School District of Mishicot
Notice of Board of Education Meeting
Monday, September 28, 2026
Regular Meeting
High School Library
660 Washington Street
Mishicot, Wisconsin 54228
5:30 PM

RE: Mishicot MS/HS Additions and Renovations
Change Request

Project Title:
Addition & Renovation to
Mishicot Middle & High School
Mishicot School District
650 Washington Street
Mishicot, WI 54228

1 UNIT F - FIRST FLOOR PIPING PLAN
Scale: 1/8" = 1'-0"

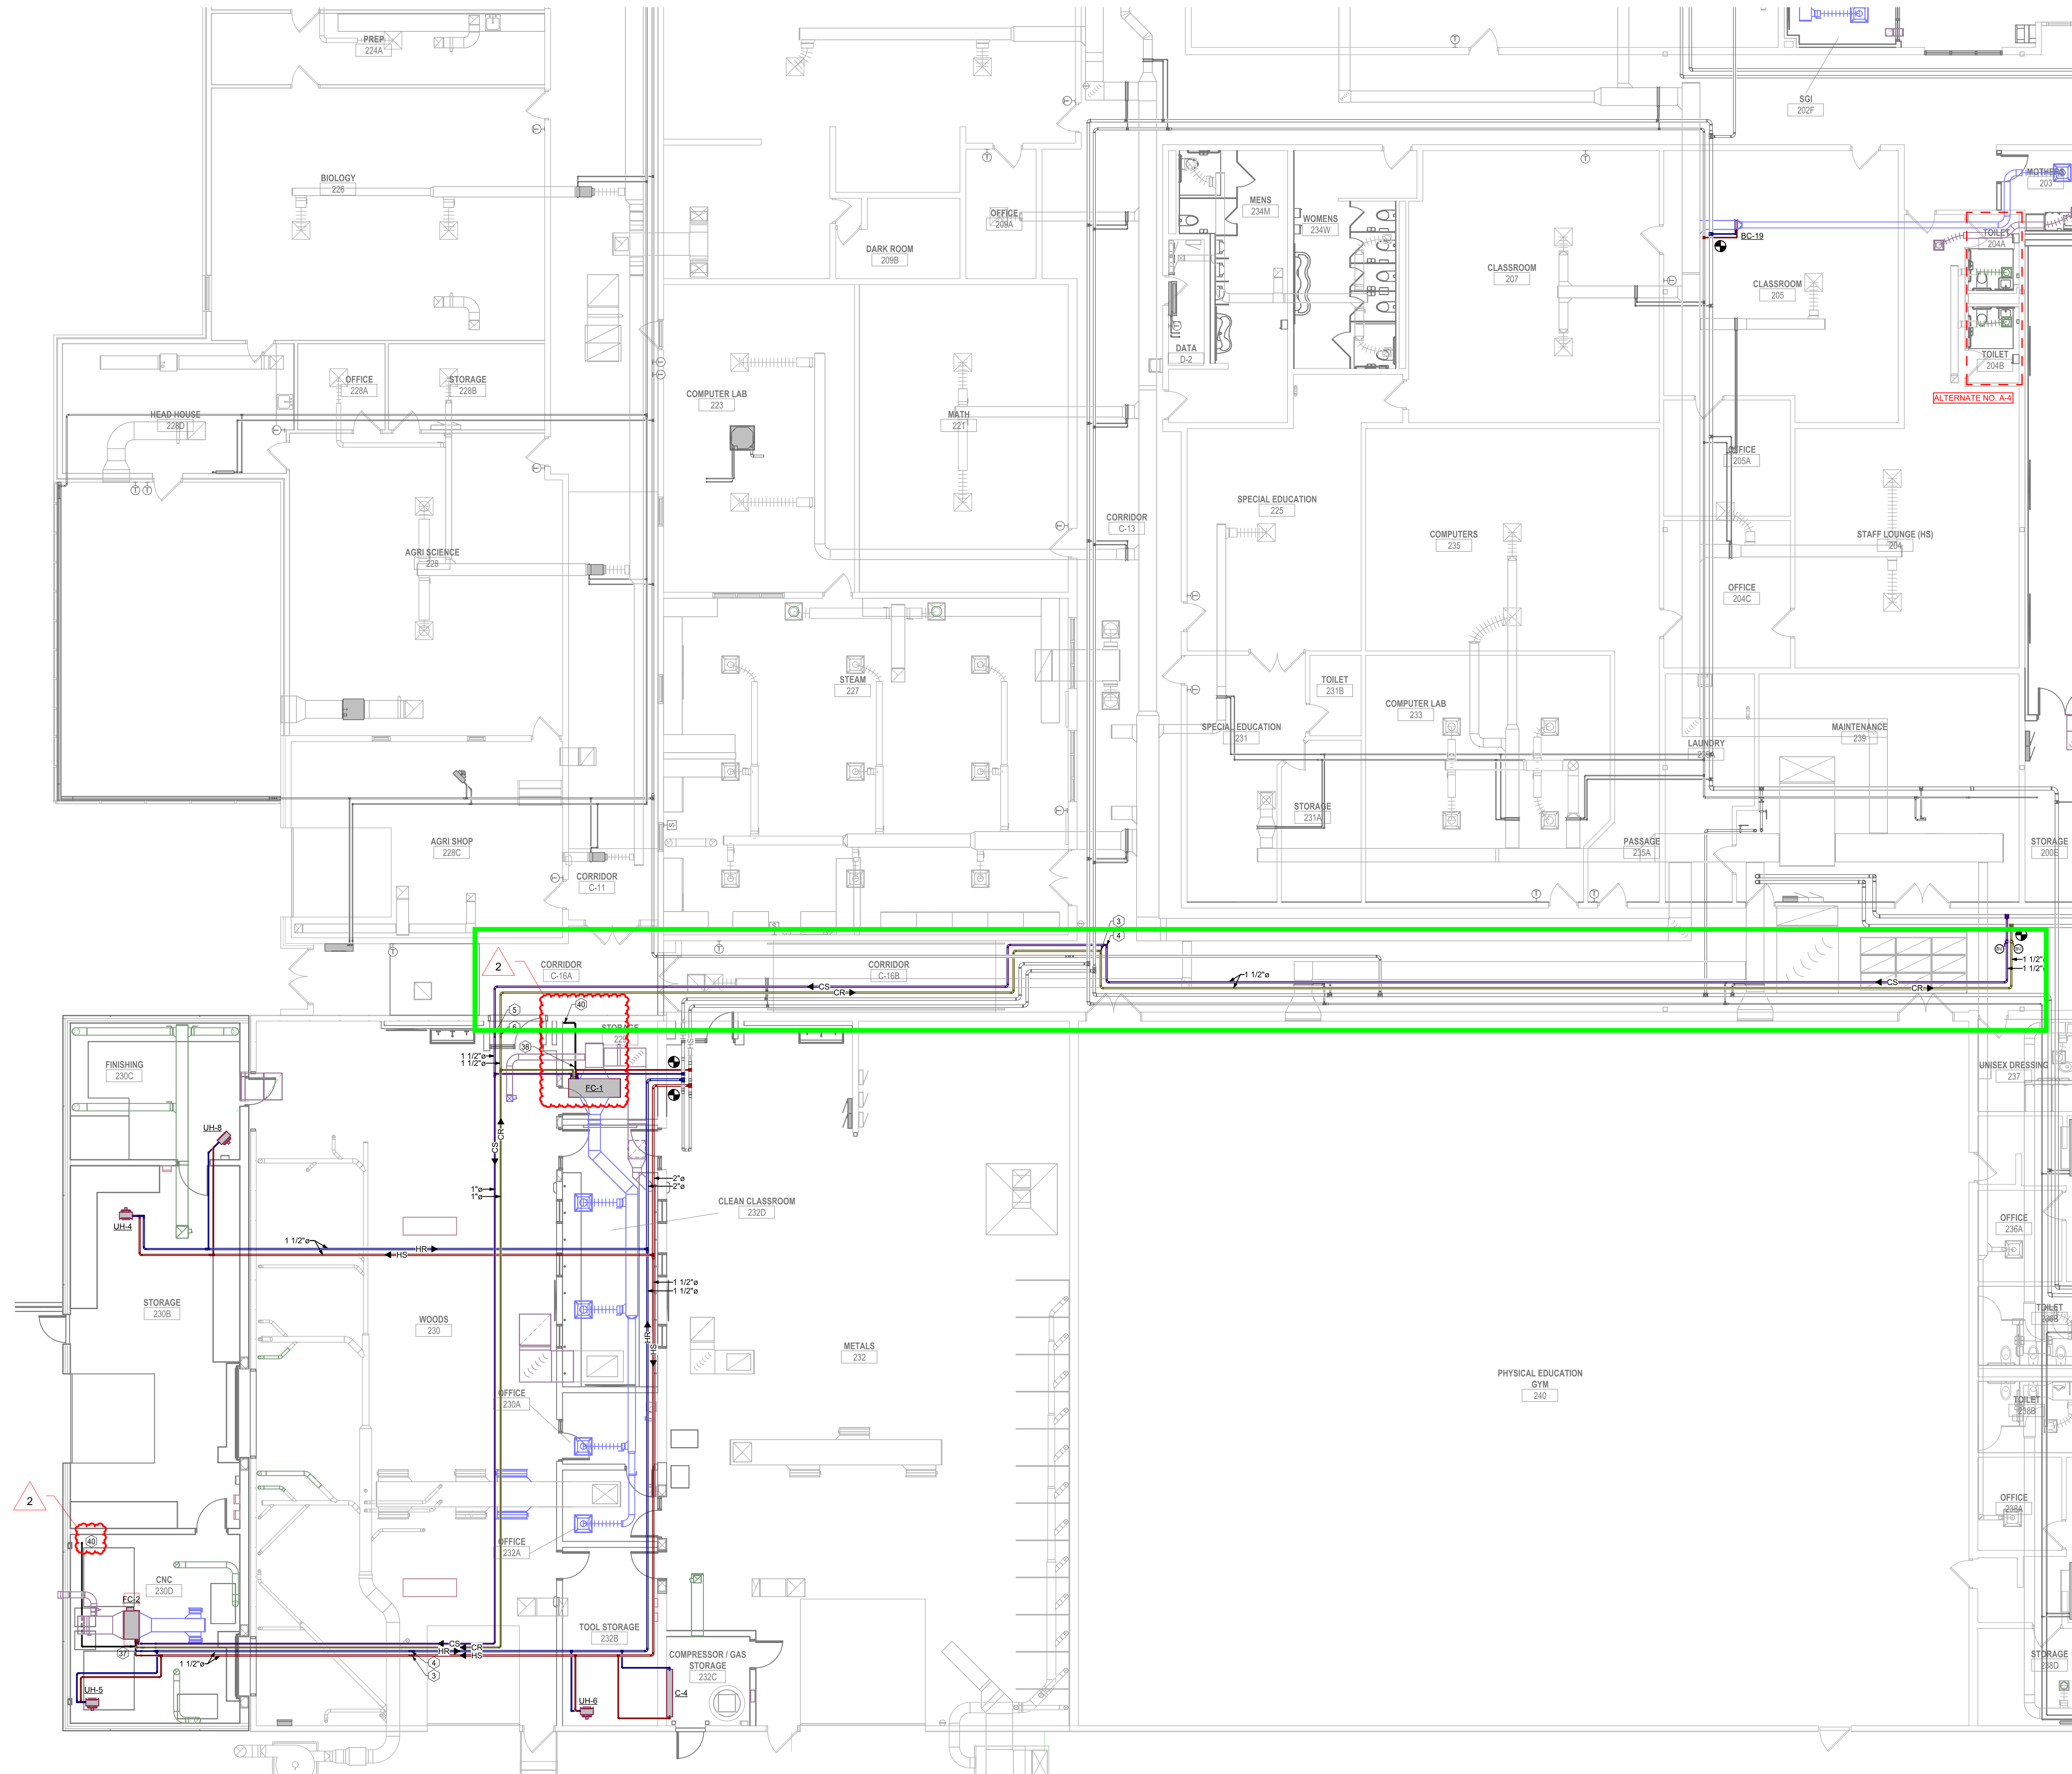
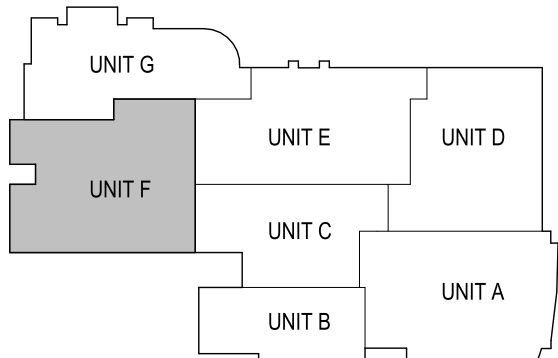
Additional Ceiling Demo (and future reinstallation) in corridor C-16B to provide access to HVAC contractor for new above-ceiling piping required to be installed leading to Tech Ed space. Ceiling demo/replacement not scheduled in this location. Work to be completed on a T&M NTE \$4,301 basis. FINAL COSTS ARE \$2,115.36

CHANGE DETAILS	
Title:	Demo and Reinstall Ceilings Area F Corridor
Scope:	Per Jos. Schmitt Construction, remove, store (on site), and reinstall ceilings as boxed on attached plan page A0.5F. Figured to be reinstalled with salvaged material - no new material figured.

There is a section of existing ceilings in Unit/Area F that we will need removed and reinstalled ASAP, that was not represented on the original demo/ceiling plans. Due to new Mechanical piping needing to be routed down to the Tech Ed. area in Unit F, the pipe fitters will need ceilings removed in corridors C-16B and a small part of C-16A (See attached marked- up drawings). We understand that these areas were not identified in the drawings, and that this will be extra work. Can you please send me a proposal to have someone come back to remove, store, reinstall these ceilings? We would be looking to get you back ASAP to do this work.

Sheet Title:
UNIT F - FIRST FLOOR RCP

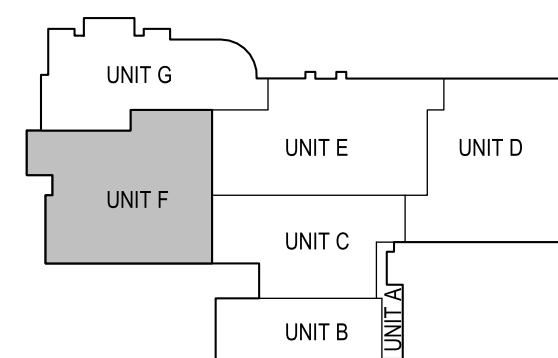
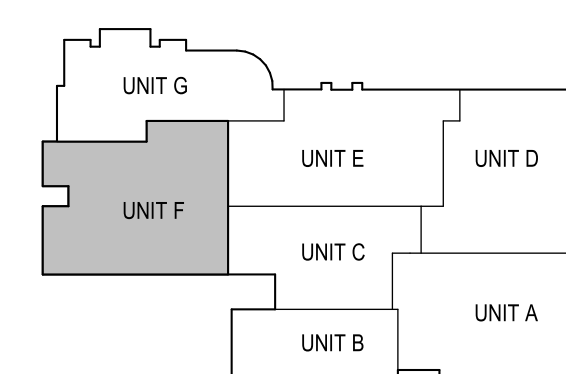
Scope: Per Jos. Schmitt Construction, remove, store (on site), and reinstall ceilings as boxed on attached plan page A0.5F. Figured to be reinstalled with salvaged material - no new material figured.

RFI #34: Plumbing - Cold Water For Toilet 108L

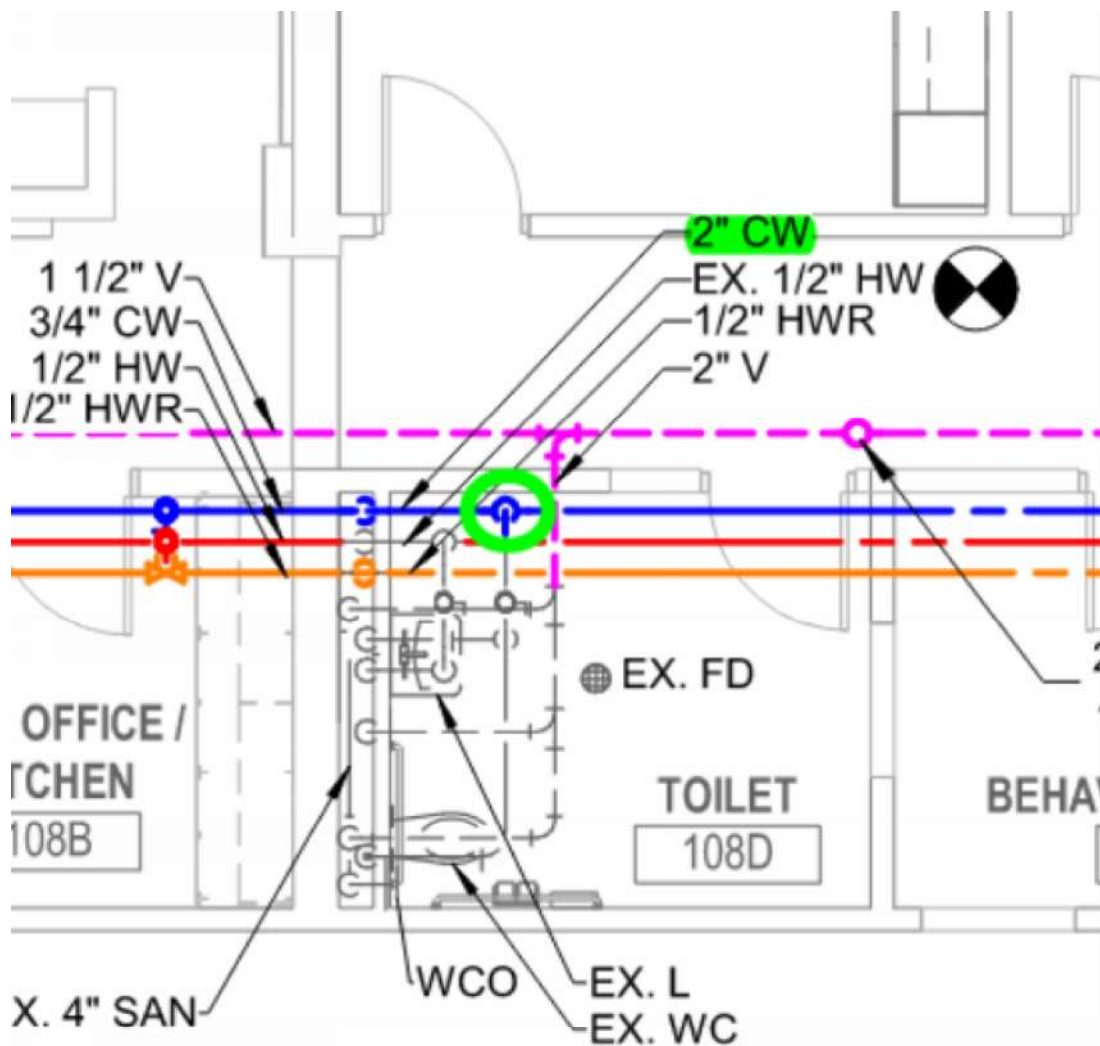
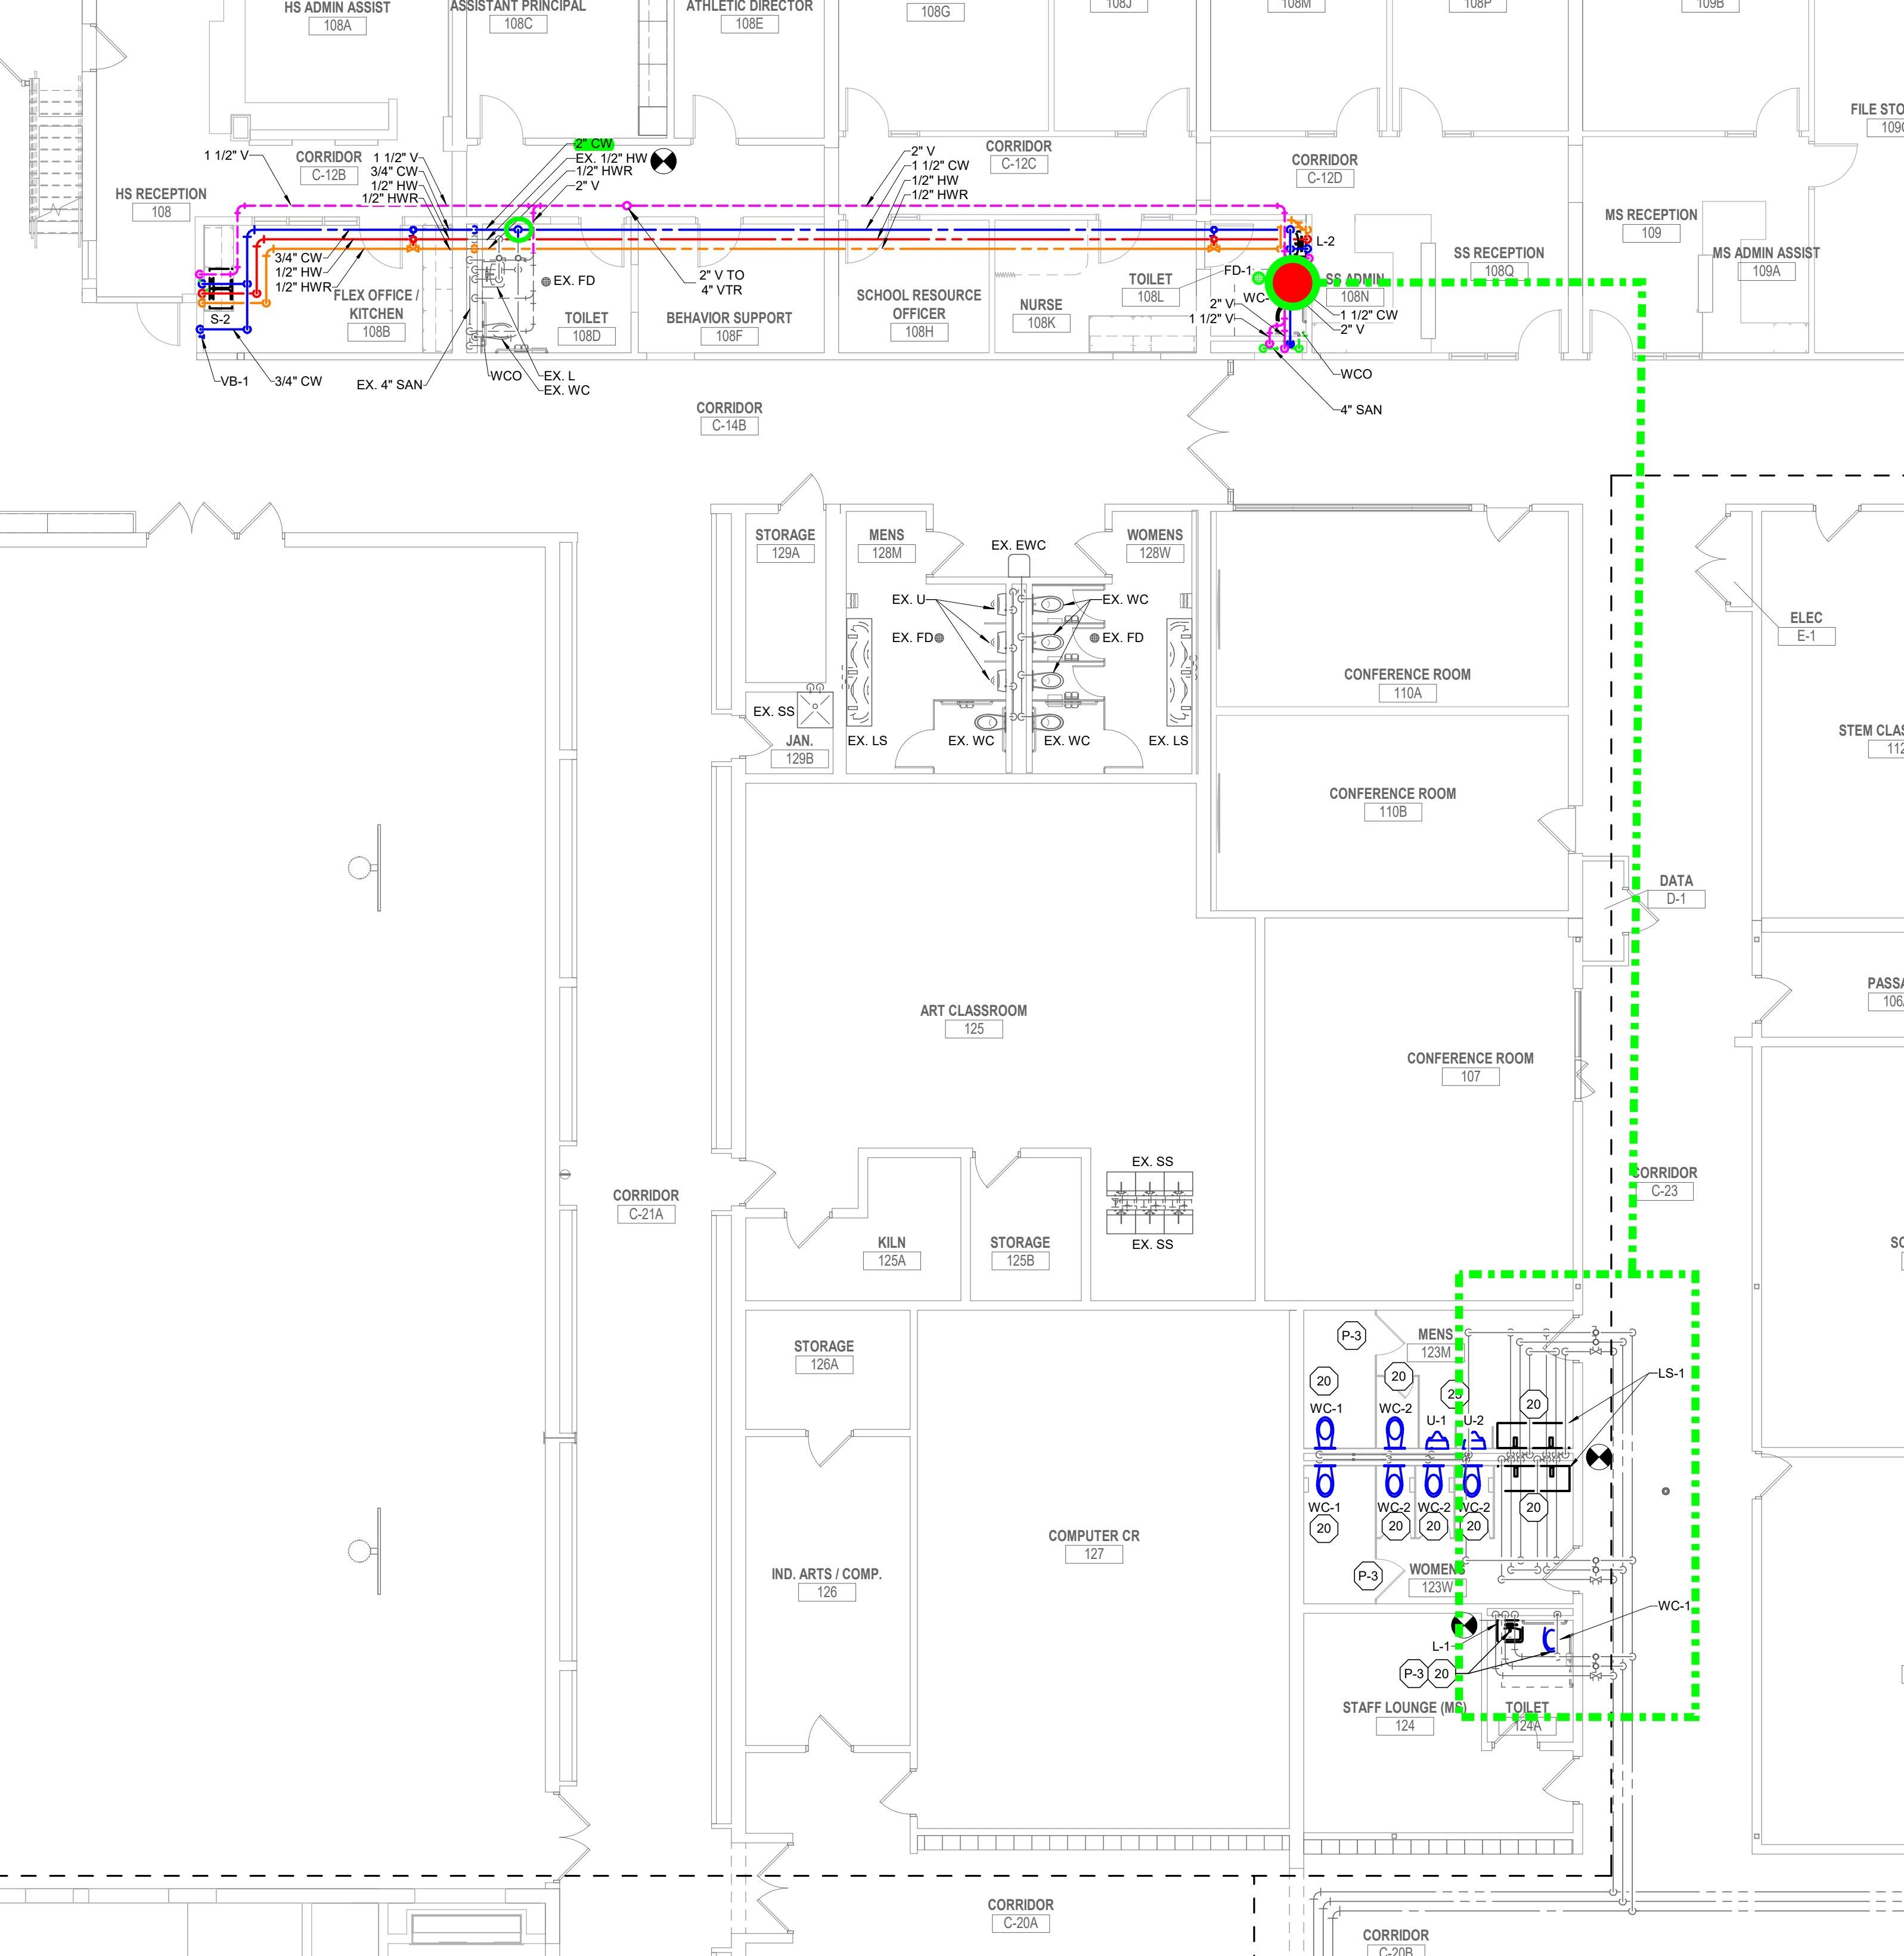
When starting rough-ins to extend the existing plumbing to feed Toilet 108L (and Flex Office/Kitchen 108B), it was discovered that the existing cold water line in Toilet 108D is only a 1-1/4" line. Knowing that we need to feed both of these rooms off of this existing 1-1/4" line, is this existing line large enough to accommodate all added fixtures?

Note, Maritime Plumbing did do some investigation and found that the nearest 2" line is near existing bathrooms 123M/W. See page 2 of the attachment, showing a potential alternate solution to connect to the existing 2" line near these bathrooms IF the existing 1-1/4" CW line is not deemed large enough to support the added fixtures in 108L (and 108B).

The existing 1 1/4" line would not be adequate to supply these bathrooms. The contractor's suggestion to connect to the 2" line near existing bathroom 123M/W is acceptable and meets the requirements of the water calc. Provide valves for cold, hot and hwr close to one another even if cold and hot/hwr are from different locations.

6.E.1. HUDL Update

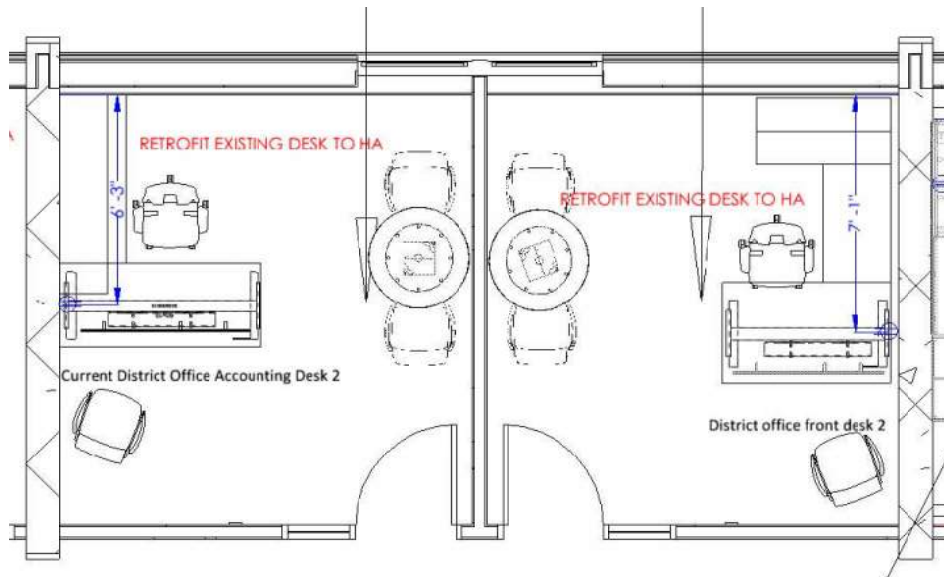
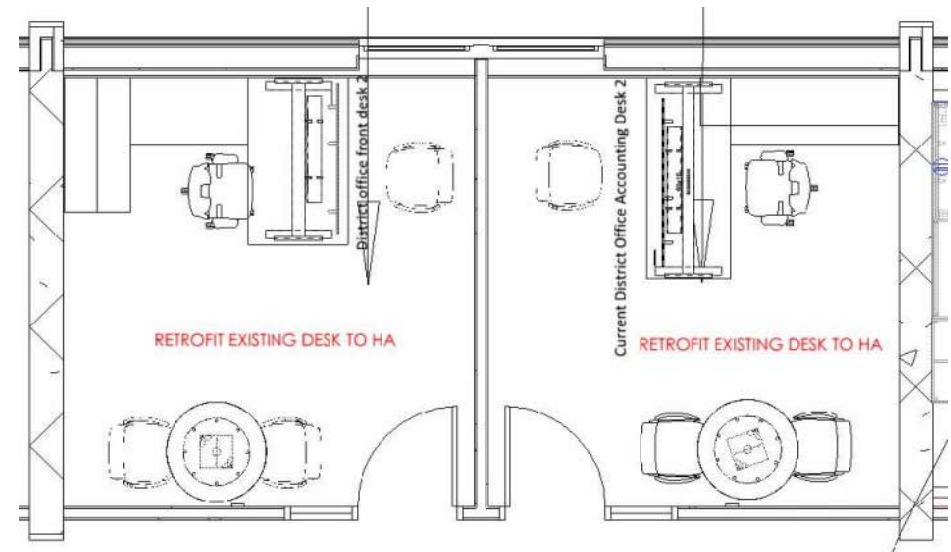
- No power or data on block wall where HA desk is located

Hubbart Electric to confirm if existing masonry walls can be fished to provide in-wall conduit. If not, outlets will need to be fed by surface mounted wire molding.

District to confirm is alternate layout option proposed by CJ & A is acceptable, this avoids electrical concerns. - JS 7/23/26
